Proposal for amendments to ECE/TRANS/WP.29/GRSG/2013/9

(Proposal for the 06 series of amendments to Regulation No. 107 - M₂ and M₃ vehicles)

The text reproduced below has been prepared by the expert from OICA to improve the provisions proposed by ECE/TRANS/WP.29/GRSG/2013/9. This document assumes that the changes proposed per document ECE/TRANS/WP.29/GRSG/2013/9 are adopted and the modifications are marked in bold for new or strikethrough for deleted characters.

"Figure 23 C

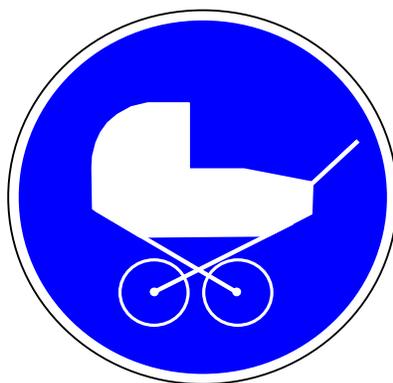
Insert a new figure 23 C, to read:

~~Example for a~~ **Pictogram for pram and pushchair area**

Colour: blue basis with white symbol

Size: at least diameter 130 mm

Reference for the design principles of safety symbols: ISO 3864-1 : 2011"
